APPEAL SUMMARY

Appeal ID: 18976	Project Address: 1015 NW 22nd Ave
Hearing Date: 2/6/19	Appellant Name: Marc Seguela
Case No.: B-026	Appellant Phone: 503-239-7377
Appeal Type: Building	Plans Examiner/Inspector: Jeff Rago
Project Type: commercial	Stories: 6 Occupancy: I-2 Construction Type: 1-A
Building/Business Name: Good Samaritan Medical Center	Fire Sprinklers: Yes - Fully sprinklered
Appeal Involves: Reconsideration of appeal	LUR or Permit Application No.: 18-251464-FA
Plan Submitted Option: pdf [File 1] [File 2]	Proposed use: I-2 Hospital

Re: Legacy Good Samaritan Medical Center
Facility Fire Life Safety Update
Portland Oregon

SIXTH FLOOR PLAN

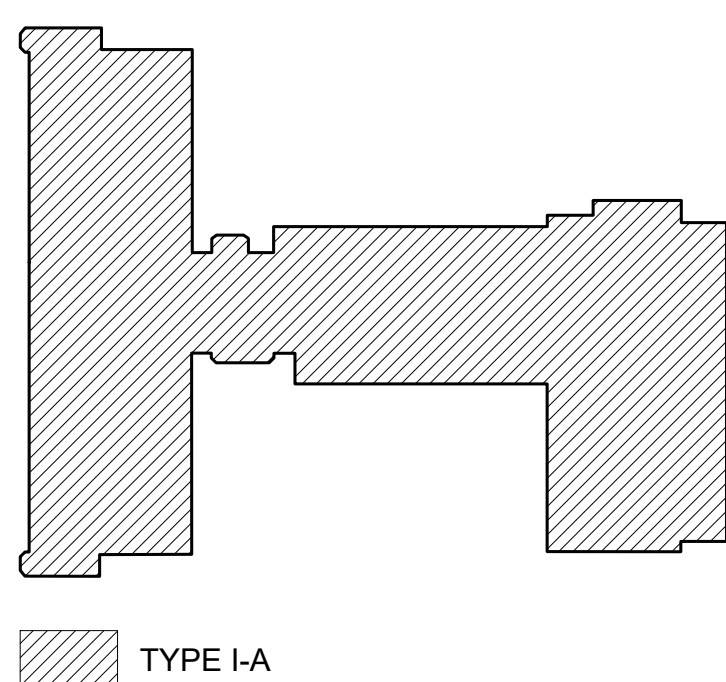
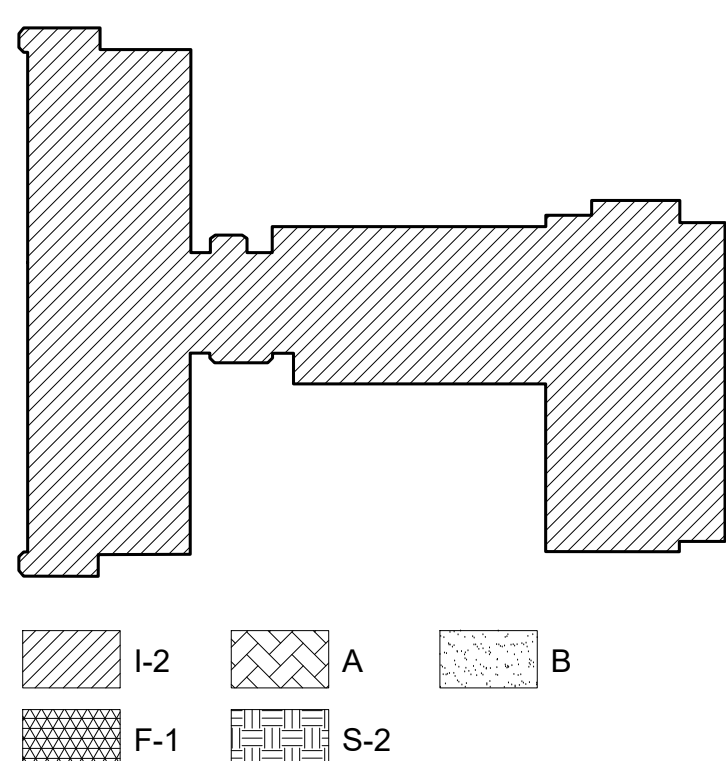
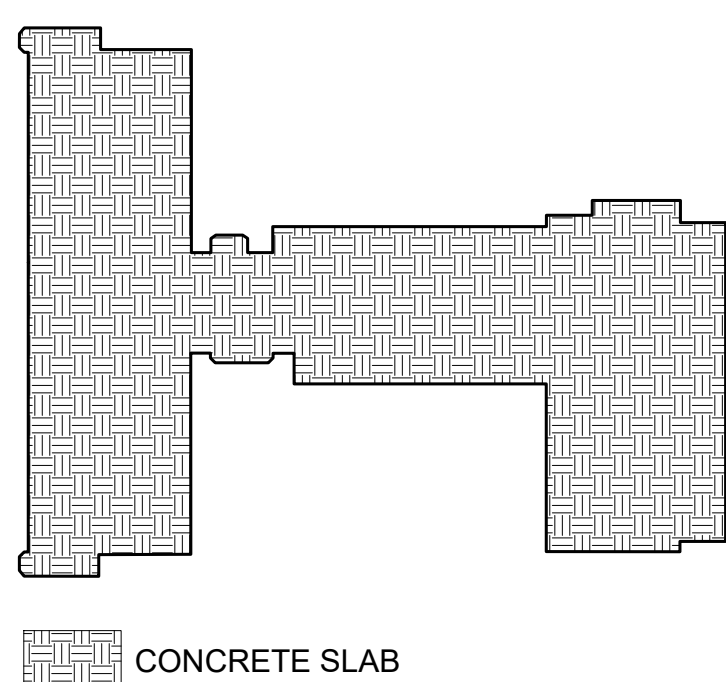
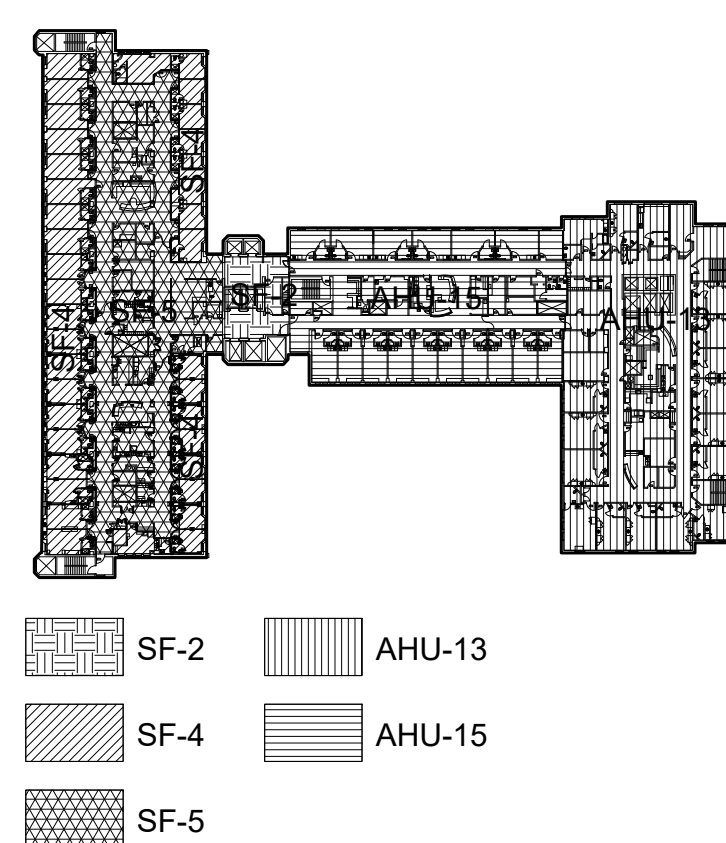
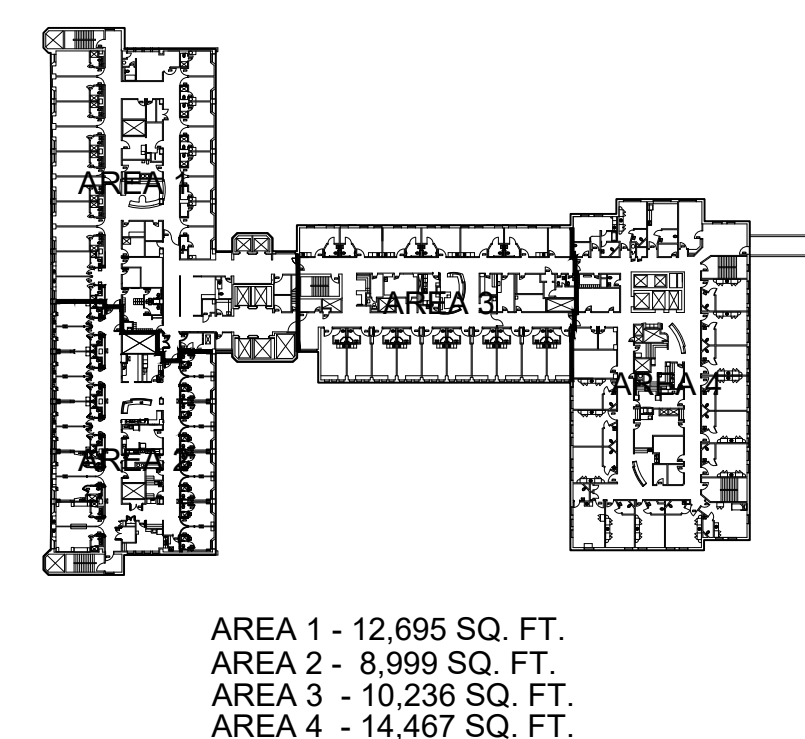
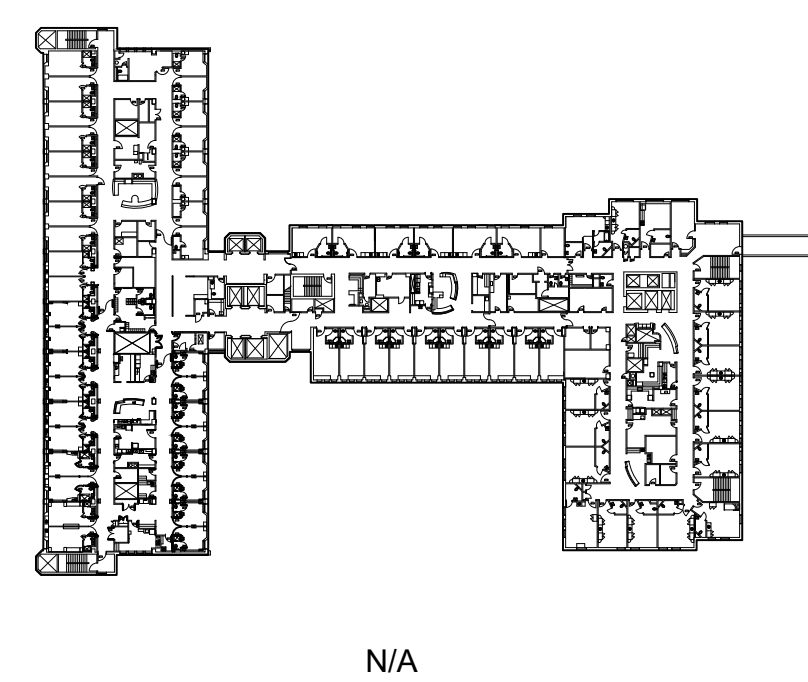
- The 6th floor central area Fire and Life safety plan will be up-dated to 2014 OSSC and 2012 NFPA 101, Chapter 19 code requirements.
- The Hospital intends to extend these updates throughout the building floors and fire compartments over time, updating to new fire code requirements (by fire compartment) as they occur and updating the Fire and Life Safety plan with the City as work occurs.

- Quick response sprinkler heads replace all standard response sprinklers throughout all areas (the work at 6th Floor central is already completed)
- Corridor walls: de-rated from 1-hour fire rating to 0-hour smoke partitions. Must remain full height (at least one layer of gypsum wallboard) to resist passage of smoke. Existing walls will remain in place as full height, with two layers of 5/8" type x gyp. Wall labels will be re-stenciled to 0-hour smoke partitions.

- Corridor wall fire dampers: No dampers required, resist the passage of smoke, Smoke Seal all penetrations. (Note: Owner prefers to maintain Fire Caulking at all penetrations throughout the Hospital) Decommissioned dampers remaining in place, receive permanent signage designating the damper as no longer in service.

- Corridor Doors: Existing doors will remain in place but may be considered as unrated. Must resist passage of smoke.
- Smoke compartment walls: 20 minute Rated Doors. Full height, 1- hour fire rated walls with 5/8" GBX each side full height.

- Shaft walls: 90 minute Rated Doors and 2- hour fire rated walls remain in place. New electronic actuated fire and smoke dampers will be installed as required to replace older fusible link type

- Hazard rooms protected per 2014 OSSC and 2012 NFPA 101 chapter 19 throughout.
- Miscellaneous work includes replacement of existing fusible link type dampers with new electronic actuated dampers. Smoke sealing at wall partitions.

Reason for alternative As the corridor and some former rated walls of 6th floor central are no longer required to maintain the fire ratings previously dictated, the fire and smoke dampers within those walls are redundant, but remain in place. Decommissioning of the dampers simplifies the HVAC system sequence of operations, the fire alarm system and reduces maintenance and upkeep effort for all of these systems.

Alterations to 6th floor of UBC building with upgrades to meet 2014 OSSC requirements: Granted provided a UBC / OSSC code comparison is completed as part of the Life Safety plan review. Appellant may contact Jeff Rago (503-823-1079) for assistance.
